Access Compliance Report

Public Rights-of-Way

(Curb Ramps)

Intersection ID: 49561	Main Street: ARTISTS_WY	Cross Street: SPENCER_ST	Location: SW
ADA ID: 35FA57275F46	Ramp Type: BlendTrans2	Initial Pass/Fail: Fail	Overall Compliance: No
Codes/Mitigation Info/Possible Solution		Field Measurements/Component Compliance	
Severity Score: 1.25

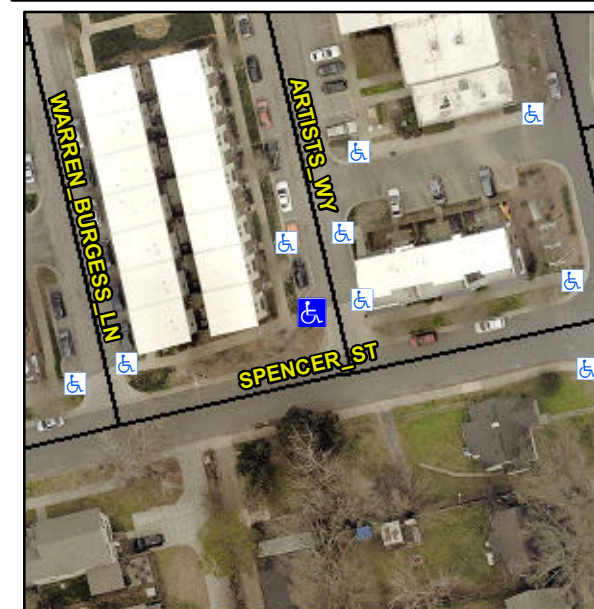
R304.5.3

Compliance	Description	Data	Compliance	Description	Data
N/A	Ramp Length (in)	61.0	Yes	BlendTrans Slope (%)	0.5
Yes	Ramp Width (in)	71.0	No	BlendTrans XSlope (%)	3.2
N/A	Flare Type LT	N/A	N/A	Flare Type RT	N/A
N/A	Flare Slope LT (%)	N/A	N/A	Flare Slope RT (%)	N/A
N/A	Flare Traversable LT?	N/A	N/A	Flare Traversable RT?	N/A
N/A	Landing Length (in)	N/A	N/A	DWS Provided?	N/A
N/A	Landing Width (in)	N/A	N/A	DWS Contrast?	N/A
N/A	Landing Slope (%)	N/A	N/A	DWS Length (in)	N/A
N/A	Landing X Slope (%)	N/A	N/A	DWS Full Width?	N/A
N/A	Landing Curb? (Y/N)	N/A	N/A	DWS Offset (in)	N/A
N/A	Shared Landing?	N/A			
N/A	Gutter Ponding?	No	N/A	Gutter Slope (%)	0.2
N/A	Gutter Lip Ht (in)	0.0	N/A	Gutter X Slope (%)	2.0
N/A	Painted X Walk1?	Yes	N/A	Painted X Walk2?	N/A
	X Walk 1 Direction	To E		X Walk 2 Direction	N/A
	X Walk 1 Width (in)	62.0		X Walk 2 Width (in)	N/A
	X Walk 1 Slope (%)	2.4		X Walk 2 Slope (%)	N/A
	X Walk 1 X Slope (%)	2.2		X Walk 2 X Slope (%)	N/A

Remove & Replace Curb Ramp With Two New Directional Ramps or Equivalent.
